WHITE SMITH SUBDIVISION, PHASE 1, **RESUBDIVISION OF LOT B**

APPLICATION NUMBER 10 DATE July 17, 2014

REQUEST Subdivision

DETAIL SITE PLAN

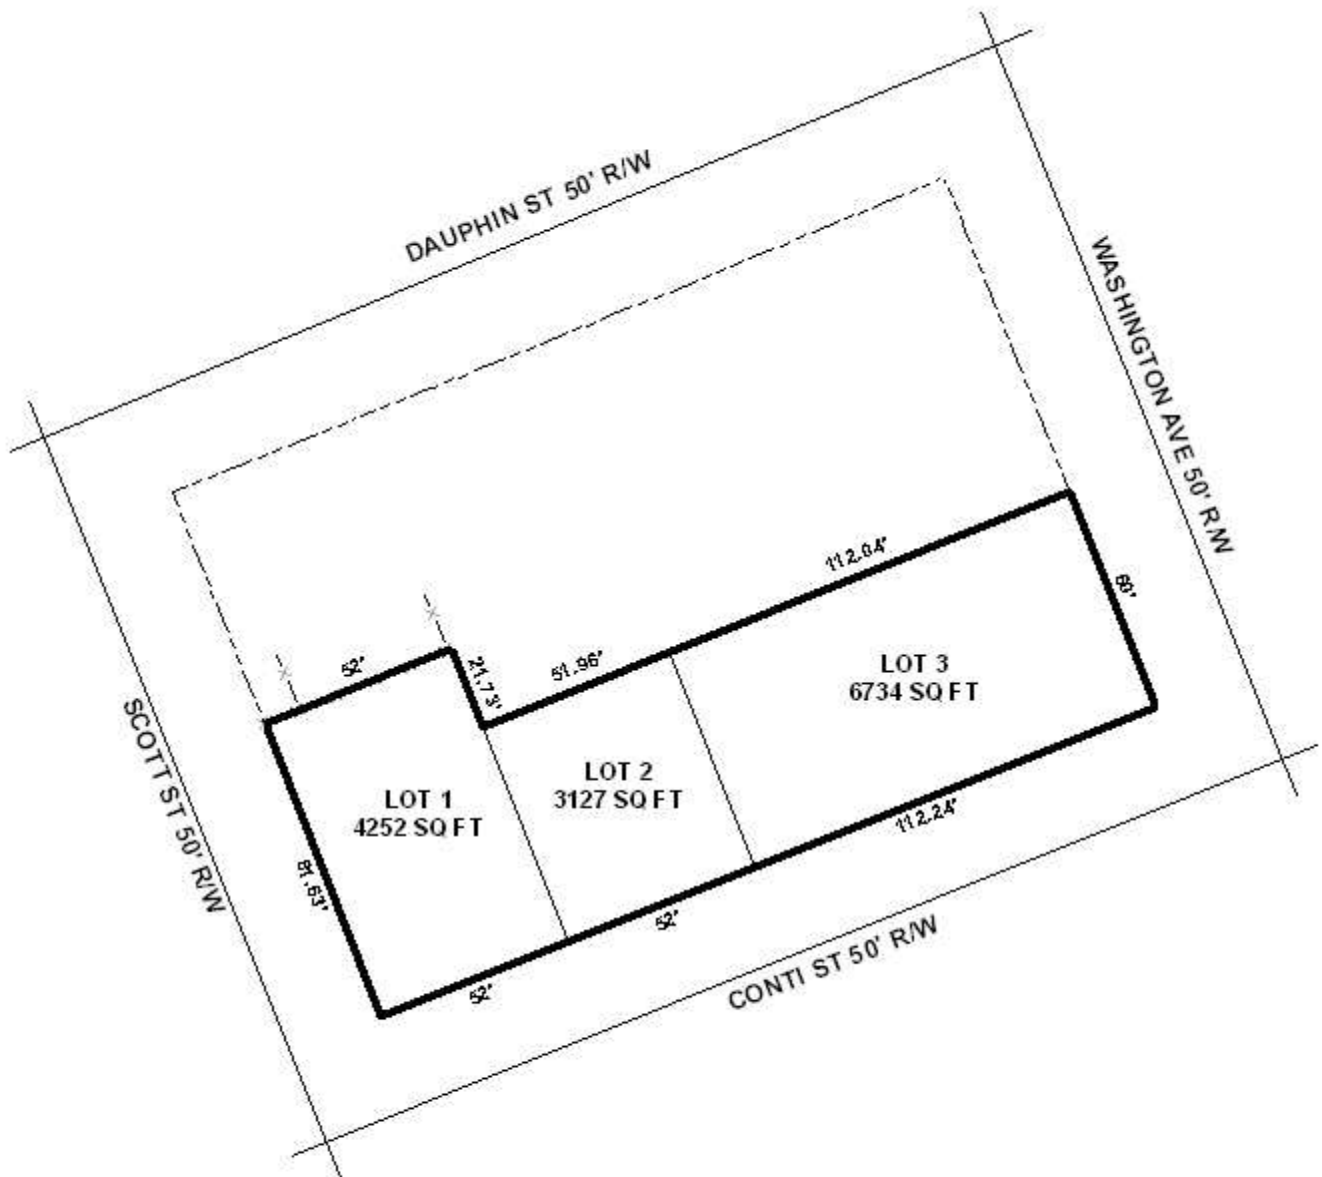
- D. Dedication of the corner radius (25' minimum or as approved by the City Engineer and Traffic Engineer).
- E. Show and label the MFFE (Minimum Finished Floor Elevation) on each LOT that contains an AE, V, or X (shaded) flood zone designation.

Traffic Engineering Comments: Driveway number, size, location and design to be approved by Traffic Engineering and conform to AASHTO standards. Lots 1-3 are limited to a total of two curb cuts to Conti Street, and Lot 1 is permitted one curb cut to Scott Street.

The site has frontage along 3 minor, "B Streets," with curb and gutter and a compliant 50' right-of-way. As such, no dedication is required; however, the provision of a corner radius in compliance with Section V.D.6. of the Subdivision Regulations should be required at the intersections of South Washington and Conti Streets and South Washington and South Scott Streets. The lot size information should be revised on the Final Plat and setbacks depicted, in compliance with Section 64-3.I. of the Zoning Ordinance, if approved.

- 1) Provision of a corner radius in compliance with Section V.D.6. of the Subdivision Regulations at the intersections of South Washington and Conti Streets and South Washington and South Scott Streets;

- 2) Revision of the lot size in square feet and acres on the Final Plat to reflect dedication;
- 3) Illustration of all setbacks on the Final Plat, in compliance with Section 64-3.I. of the Zoning Ordinance;

- 4) Placement of a note on the Final Plat stating: *(Development of the site must comply with local, state and federal regulations regarding flood zones.);*

- 6) Placement of a note on the Final Plat and compliance with Traffic Engineering Comments: *(Driveway number, size, location and design to be approved by Traffic Engineering and conform to AASHTO standards. Lots 1-3 are limited to a total of two curb cuts to Conti Street, and Lot 1 is permitted one curb cut to Scott Street.);*
